Broadcast Products Technical Bulletin 20-2005-012

SUBJECT: SWITCHING NOISE

MODEL: BKM-120D/1

Figure 1

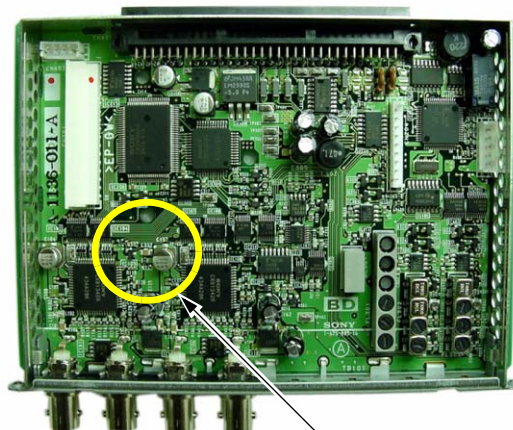
1. Remove the jumper from IC208 pin 31.
2. Add the following parts: (See Figure 1.)
 - C332, 1 μ F
 - R162, 100 k Ω
 - Q337, DTA144EK
3. Implement the modification procedure for BVM-D9H described in Technical Bulletin 20-2004-165.

ADD C332, R162, Q337

Figure 2

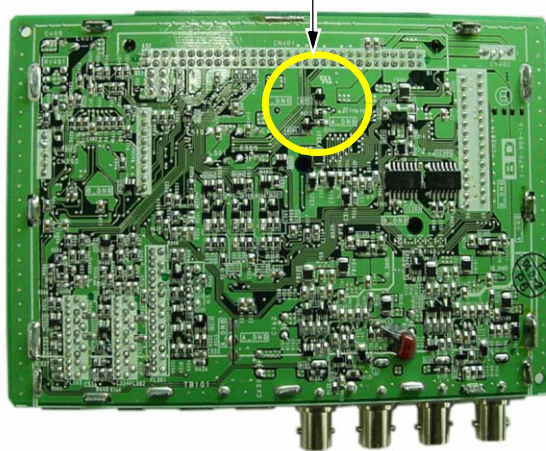
1. Remove R222, R223, Q205, and Q206. (See Figure 2.)
2. Implement the modification procedure for BVM-D9H described in Technical Bulletin 20-2004-165.

REMOVE R222, R223, Q205, Q206
